Access Compliance Report

Public Rights-of-Way

Intersection ID: 3999	Main Street: CULLINGFORD_LN	Cross Street: AMBLESIDE_DR	Location: NW
ADA ID: 60597B7D7FE6	Ramp Type: BlendTrans2	Initial Pass/Fail: Fail	Overall Compliance: No
			Severity Score: 18.75

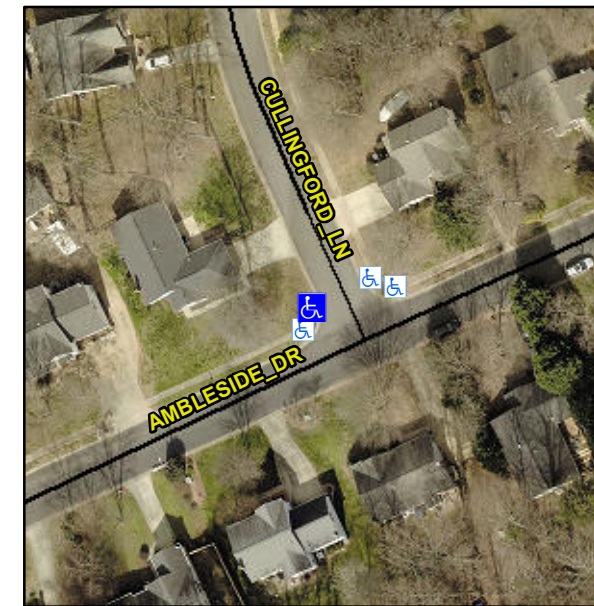
Not Found, R304.5.1, R304.5.3

Compliance	Description	Data	Compliance	Description	Data
N/A	Ramp Length (in)	93.0	Yes	BlendTrans Slope (%)	3.1
No	Ramp Width (in)	34.0	No	BlendTrans XSlope (%)	2.8
N/A	Flare Type LT	N/A	N/A	Flare Type RT	N/A
N/A	Flare Slope LT (%)	N/A	N/A	Flare Slope RT (%)	N/A
N/A	Flare Traversable LT?	N/A	N/A	Flare Traversable RT?	N/A
N/A	Landing Length (in)	N/A	N/A	DWS Provided?	N/A
N/A	Landing Width (in)	N/A	N/A	DWS Contrast?	N/A
N/A	Landing Slope (%)	N/A	N/A	DWS Length (in)	N/A
N/A	Landing X Slope (%)	N/A	N/A	DWS Full Width?	N/A
N/A	Landing Curb? (Y/N)	N/A	N/A	DWS Offset (in)	N/A
N/A	Shared Landing?	N/A			
N/A	Gutter Ponding?	N/A	N/A	Gutter Slope (%)	N/A
N/A	Gutter Lip Ht (in)	N/A	N/A	Gutter X Slope (%)	N/A
N/A	Painted X Walk1?	No	N/A	Painted X Walk2?	N/A
	X Walk 1 Direction	To NE		X Walk 2 Direction	N/A
	X Walk 1 Width (in)	N/A		X Walk 2 Width (in)	N/A
	X Walk 1 Slope (%)	2.3		X Walk 2 Slope (%)	N/A
	X Walk 1 X Slope (%)	1.6		X Walk 2 X Slope (%)	N/A

N/A	Ramp inside XWalk1?	N/A	N/A	Ramp inside XWalk2?	N/A
	Road Slope (%)	1.6		Clear Space?	N/A
	Road X Slope (%)	2.3	N/A	Clear Space to XWalk (in)	N/A
N/A	Any Obstructions?	N/A	N/A	Storm Grate/Utility Hazard?	N/A
	Obstruction Type			Storm Grate/Utility Type	
		N/A			N/A
			Yes	Surface Condition? (G/P)	Good
			No	Curb Slope (%)	12.4

Remove & Replace Curb Ramp With Two New Directional Ramps or Equivalent.
